To Serial Number FP002243. Also Ser. Numbers 34/xxxxx

1-Speed, 120 Volt, 1 Phase, 60Hz., 1/2 HP.

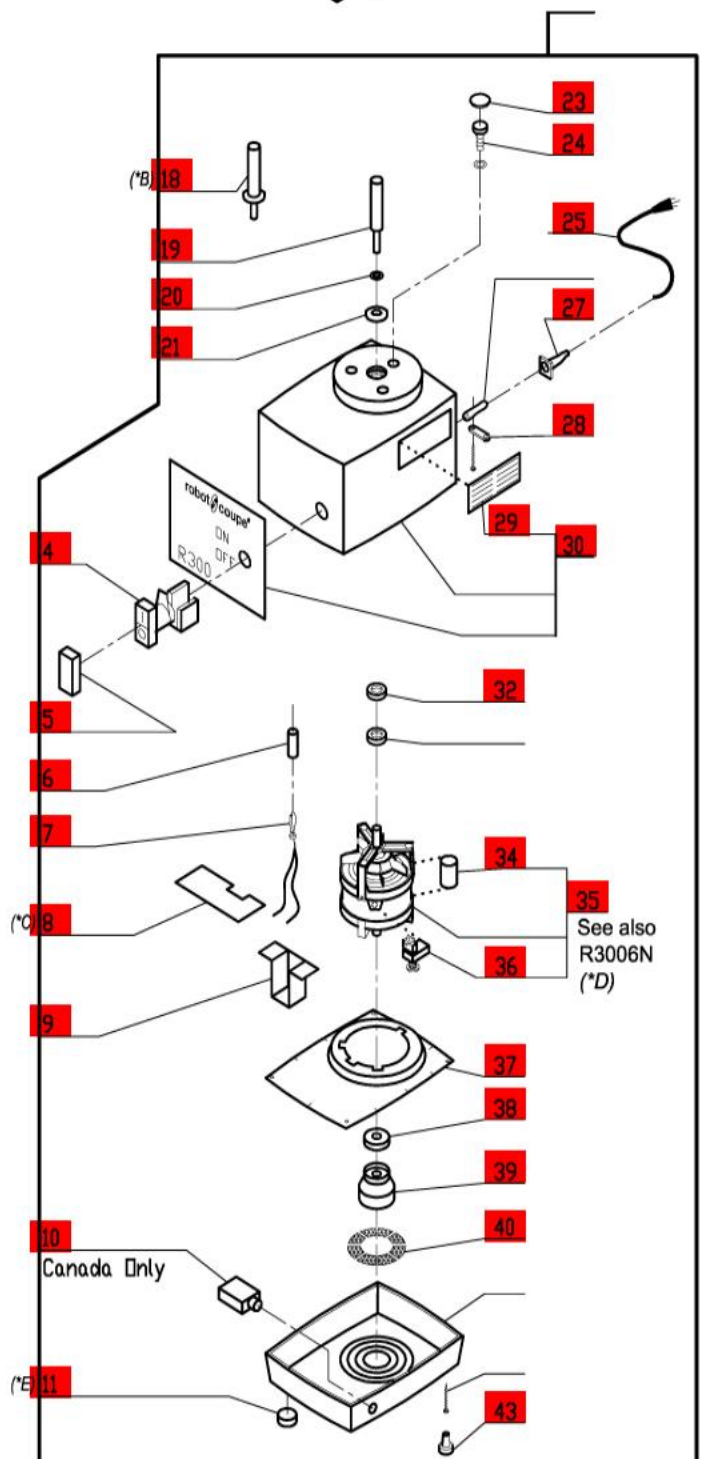
(*B) Plastic shaft cover is still available for machines 12/xxxxx

(*C) Part number R3040 comes complete with magnetic switch.

(*D) R3006N motor with plastic shaft cover R3024 is no longer available. Use a R3006U motor with R3064U shaft, R3065U deflector, R240 power cord, R3034 strain relief, and R3045 cord protector.

The R3006UB motor and the R3006K motor conversion kit cannot be used on R300 models.

(*E) After serial number 34/36801 use R101 white foot.
